CHANGE ORDER NO. 2

OWNER	City of Baxter	DATE	August 13, 2026
CONTRACTOR	RL Larson Excavating, Inc.	SEH No.	BAXTE 184519
ENGINEER	SEH	City No.	4068
Project	2026 Clearwater Road, North Lynndale Area, and Brentwood Circle Street & Utility Improvements

Revised Drawing Nos. 46-47, 53, 56, 66, 68- 70, dated 07/14/2026.

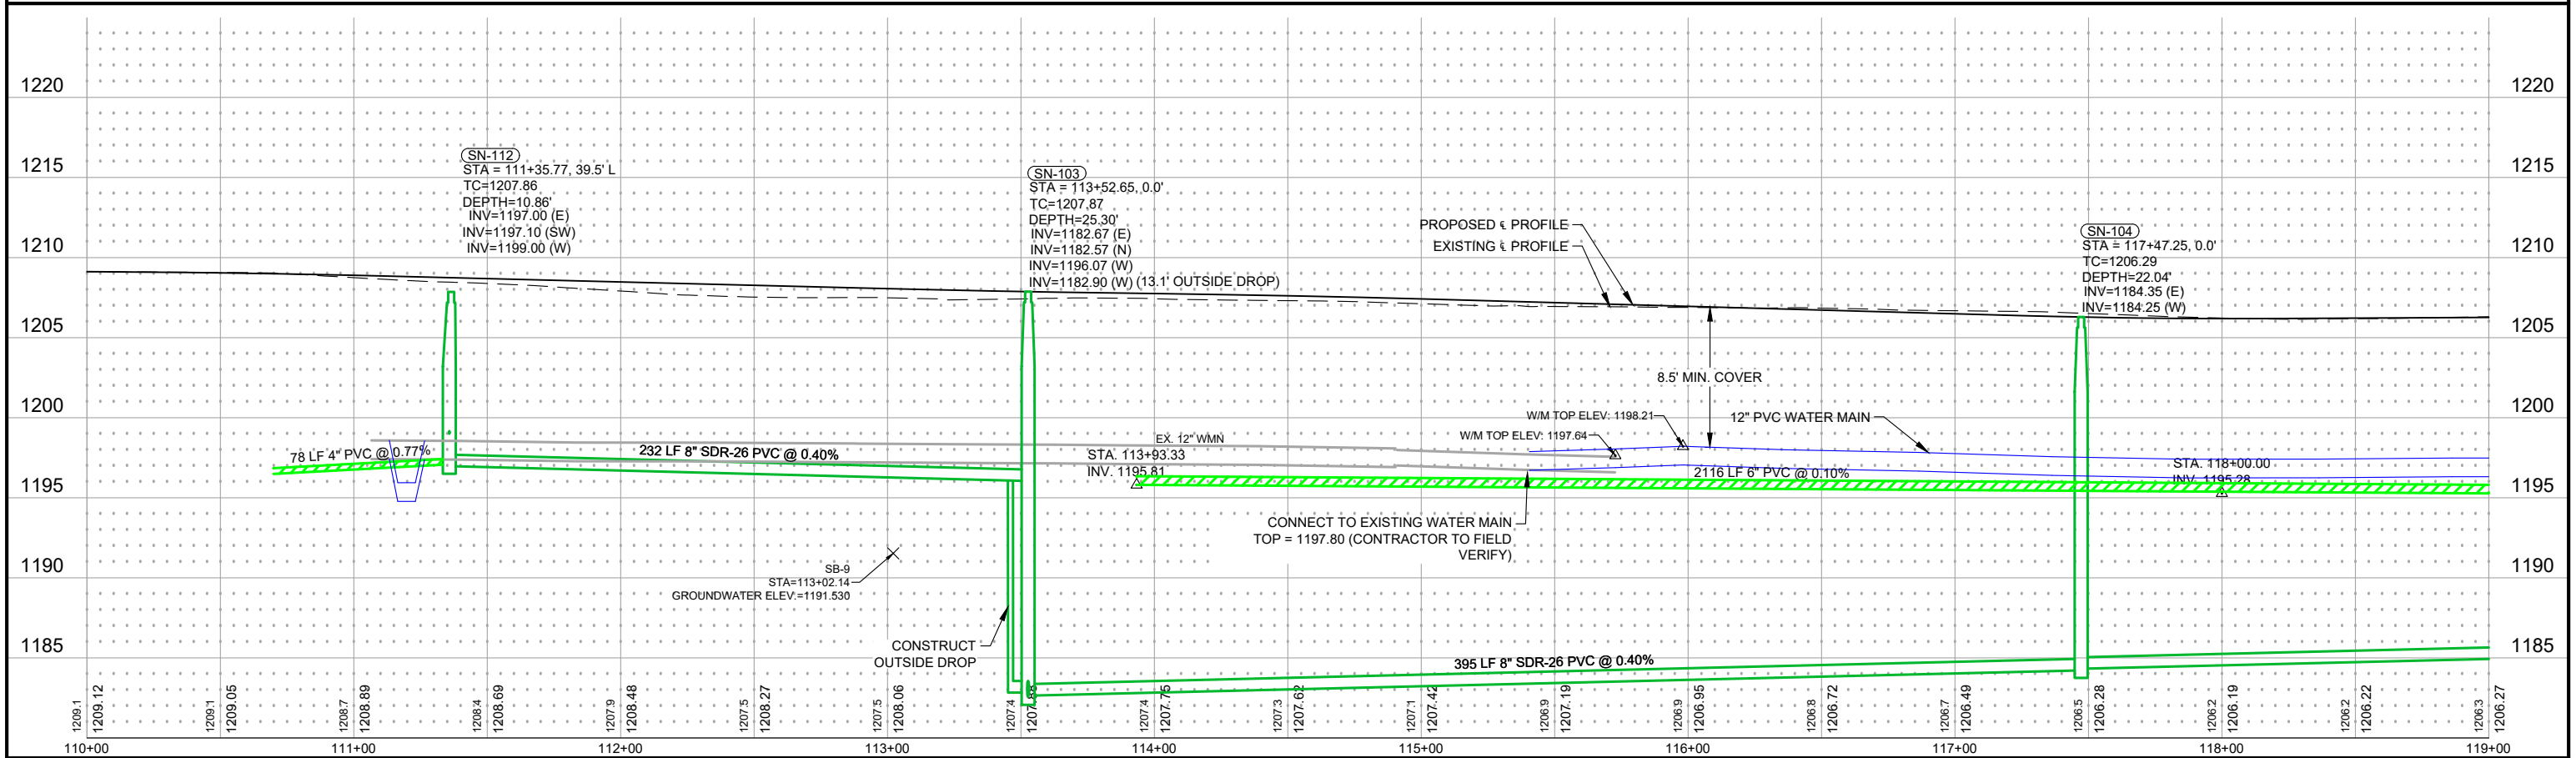
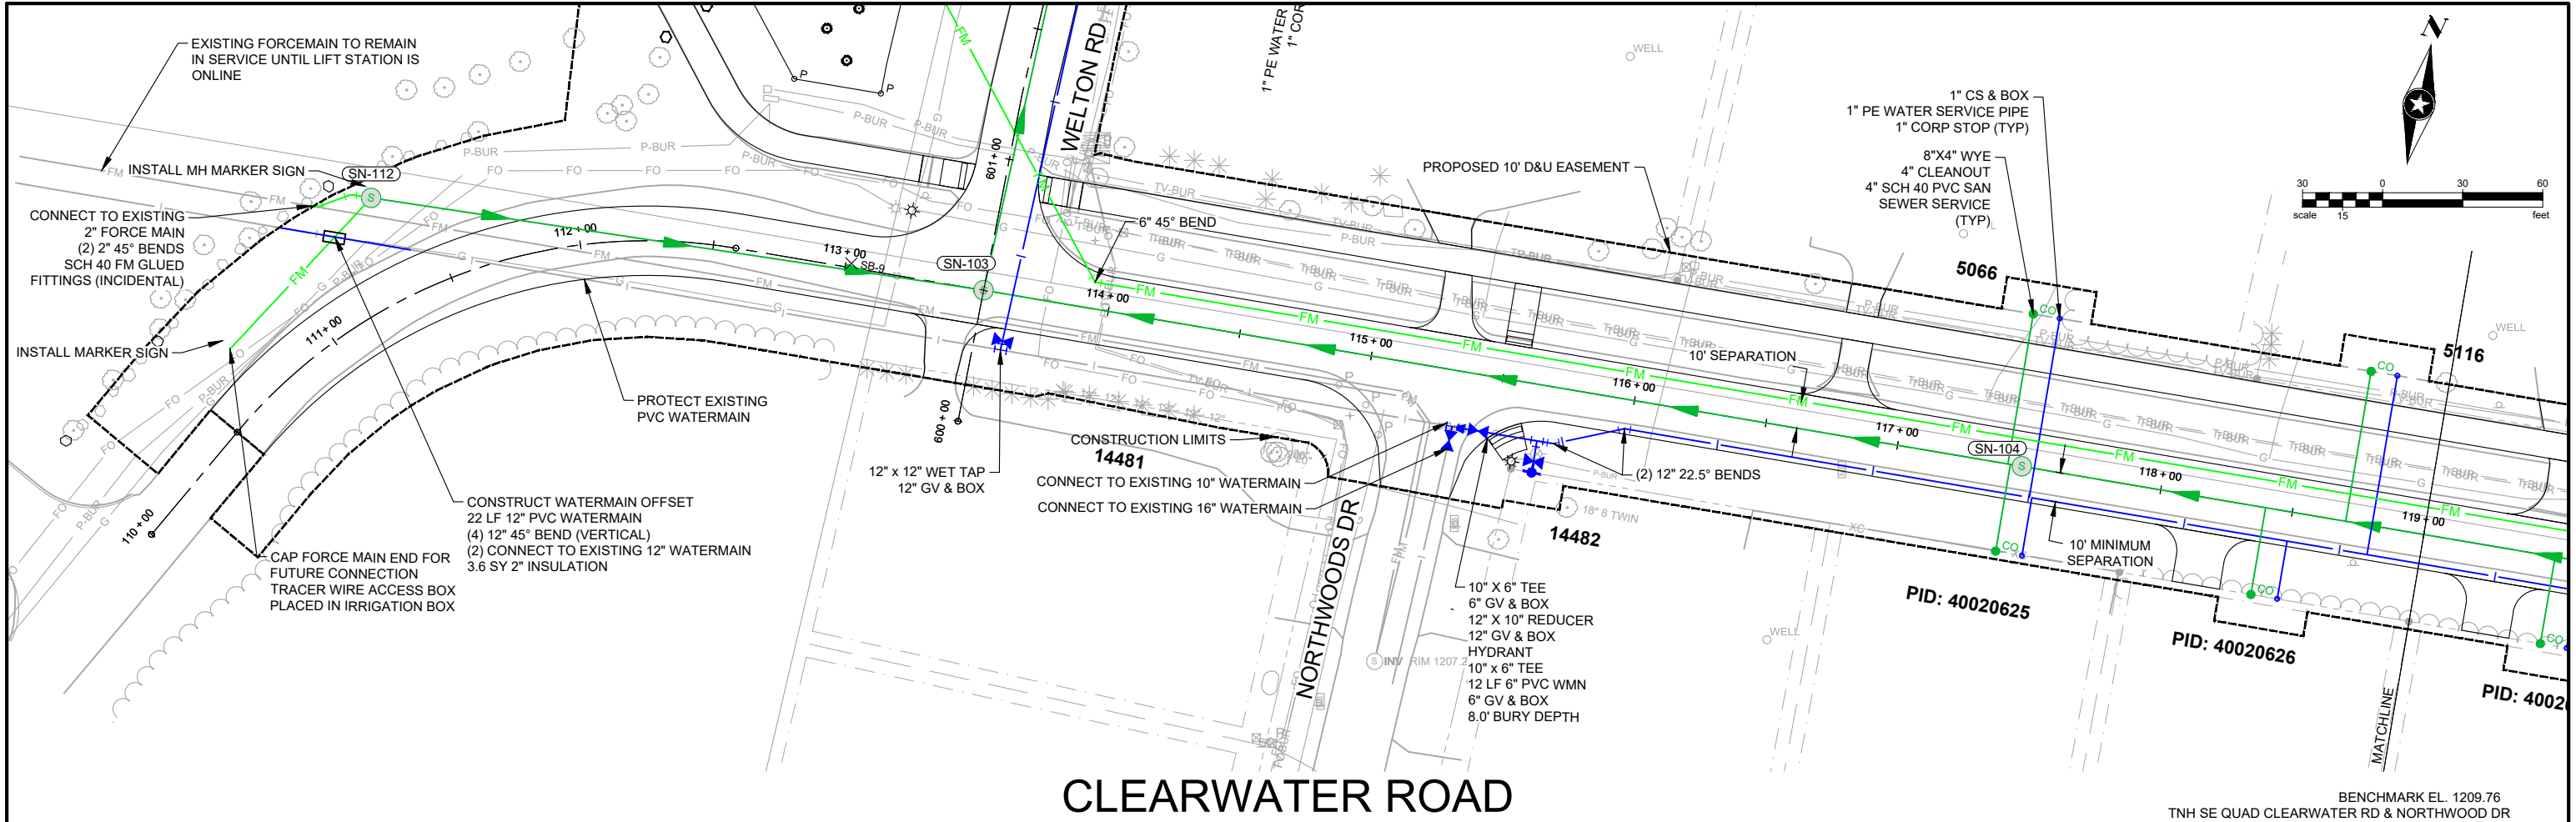
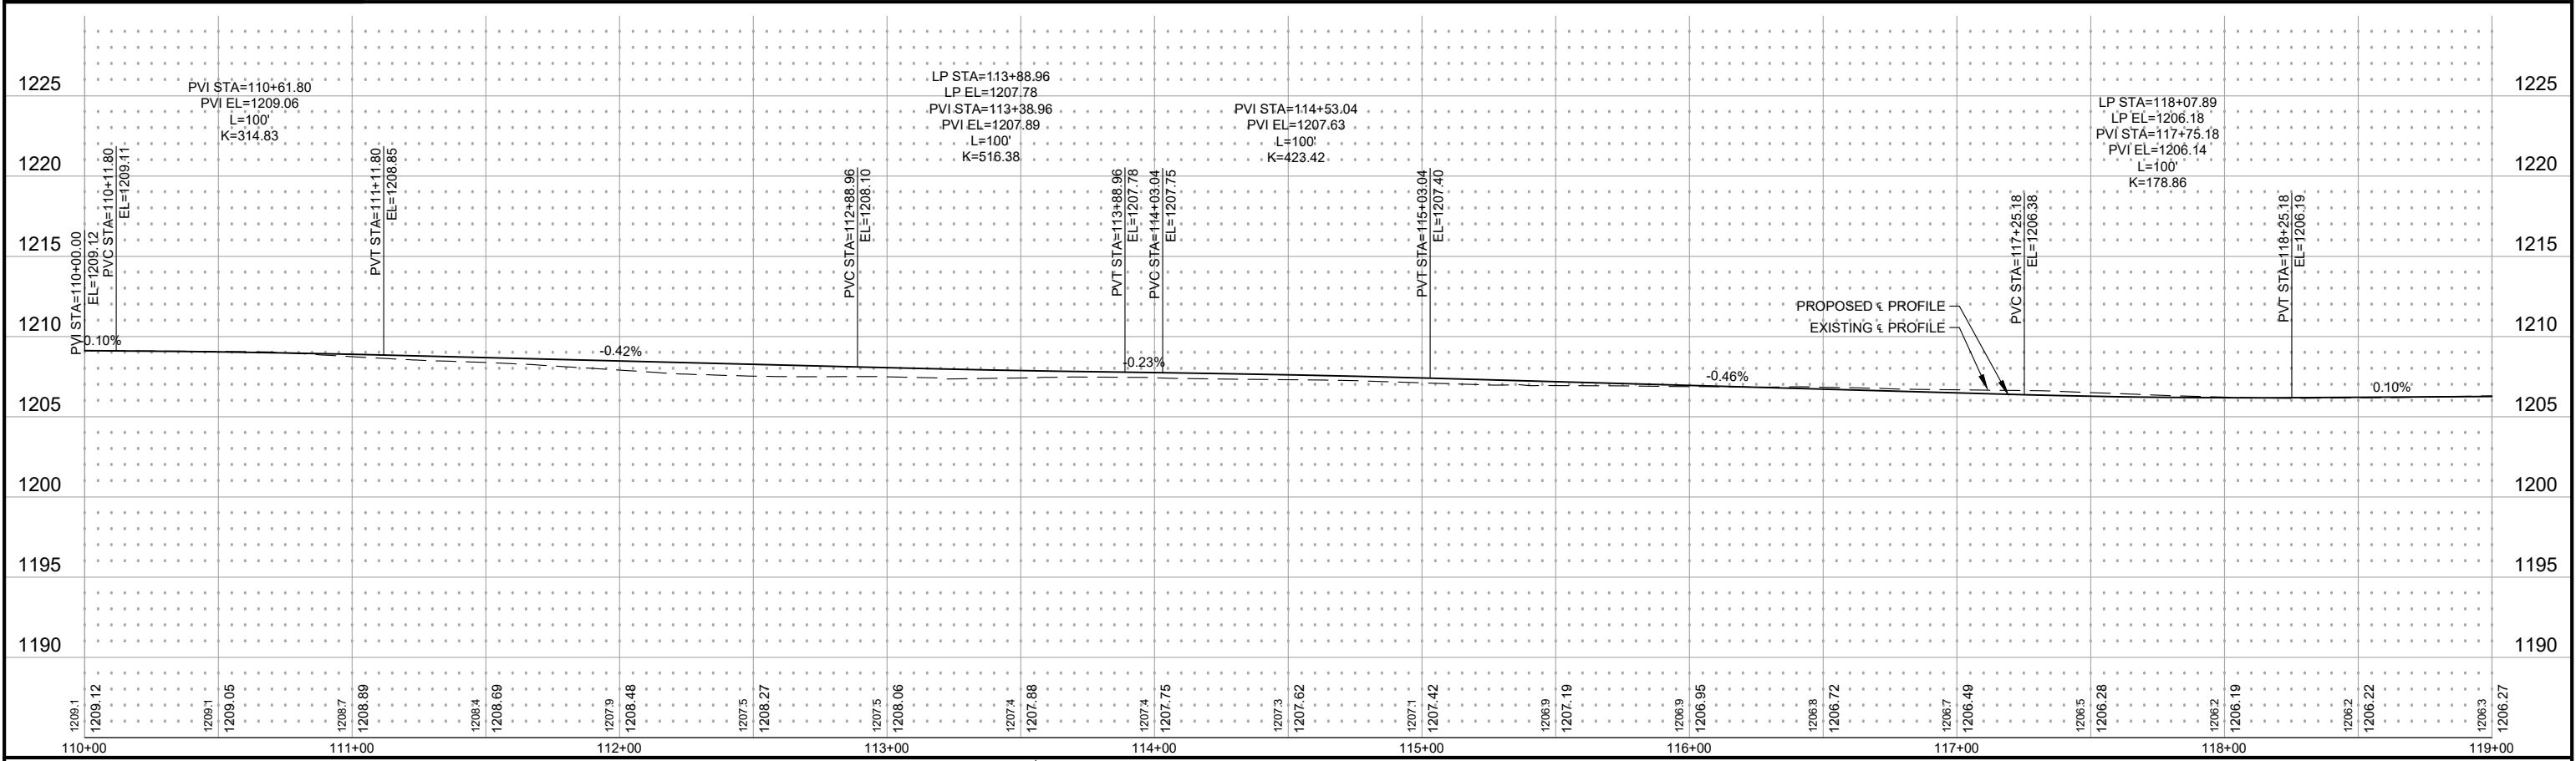
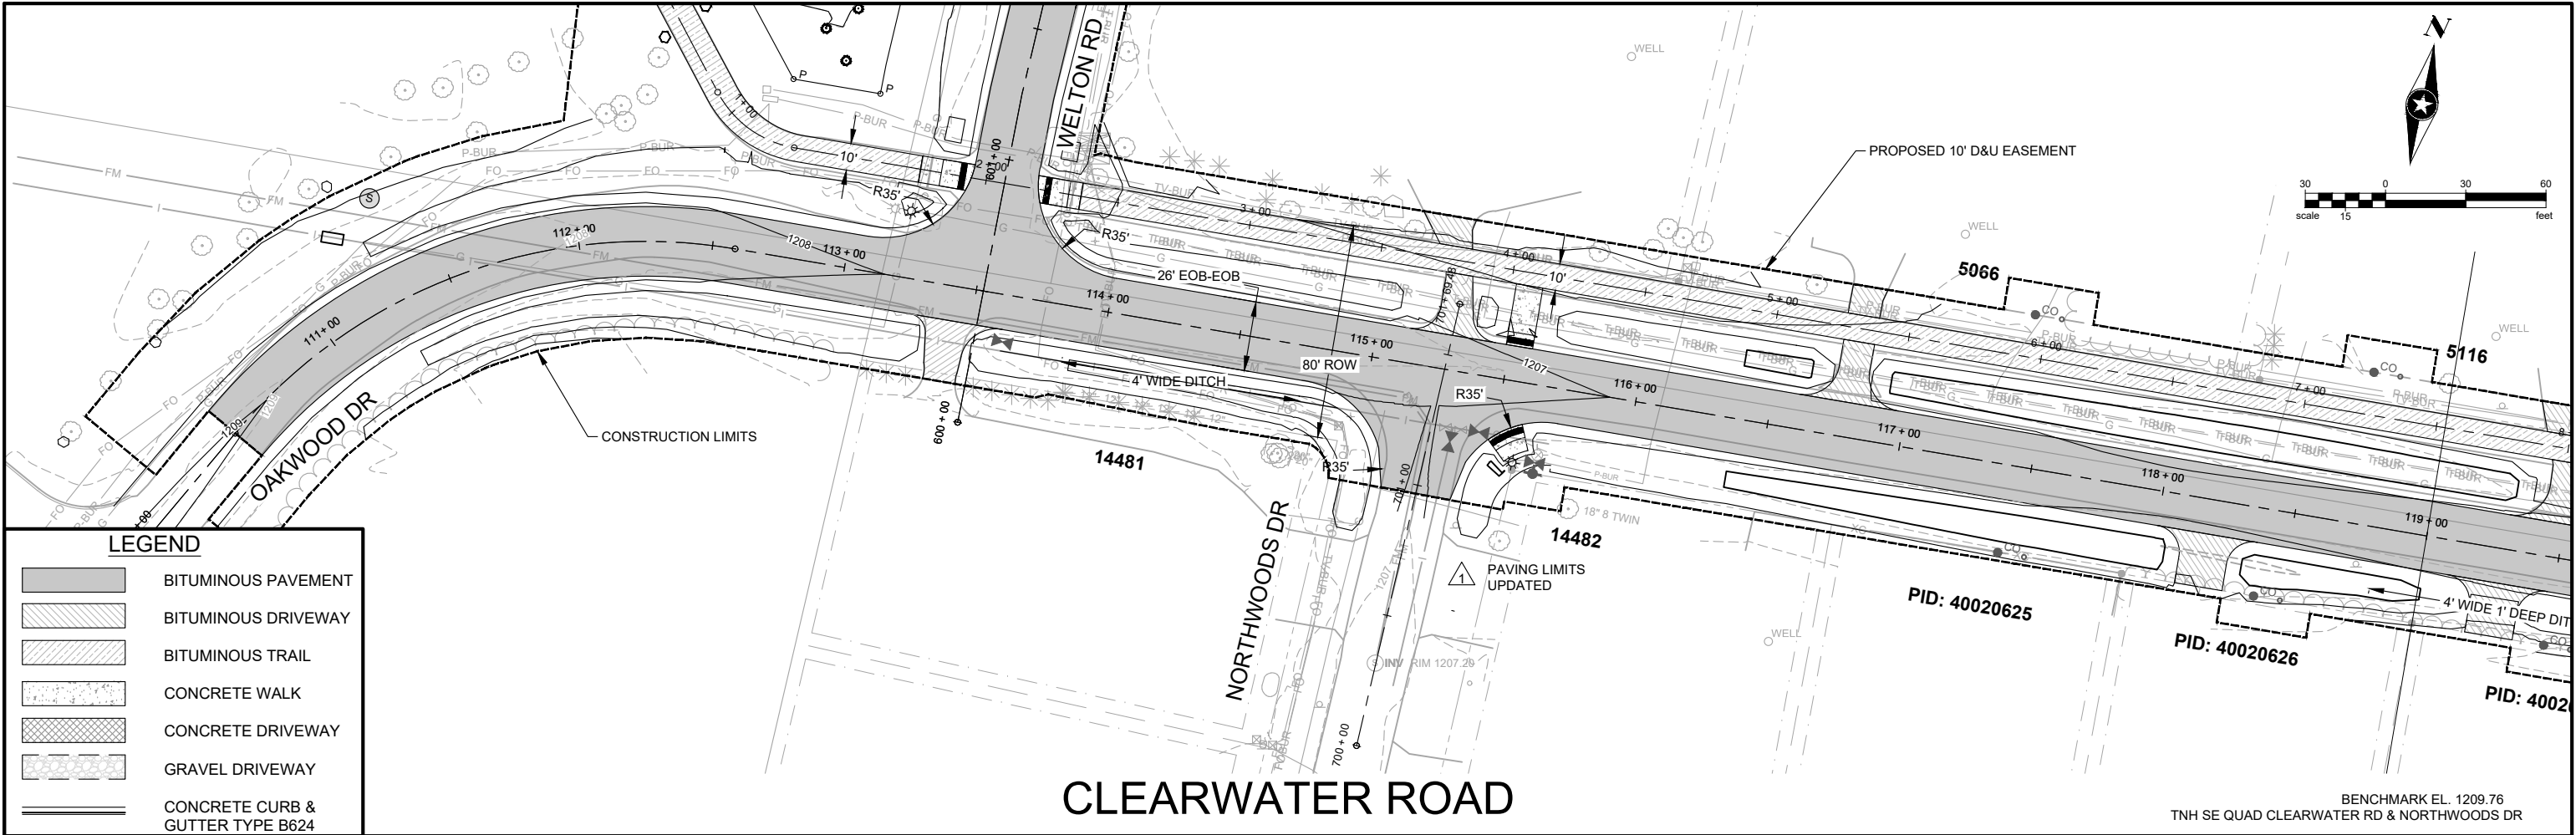
After discussion and review with City Staff, a short segment of existing 10-inch watermain and the existing 12-inch watermain along the south side of Clearwater Road between Welton Road and Northwood Drive will be left in place. This change results in a reduction of several contract quantities and requires the installation of a 12-inch by 12-inch wet tap to connect the proposed watermain. Additionally, because the originally specified 12-inch valves had already been procured, this revision will result in associated valve restocking fees, which are included in the cost impacts of this change.

As part of a plan change in this area, existing forcemain stubs along Northwoods Drive and Cottage Grove Drive will be abandoned in place. This change allows the removal and restoration limits to be reduced, resulting in several quantity reductions.
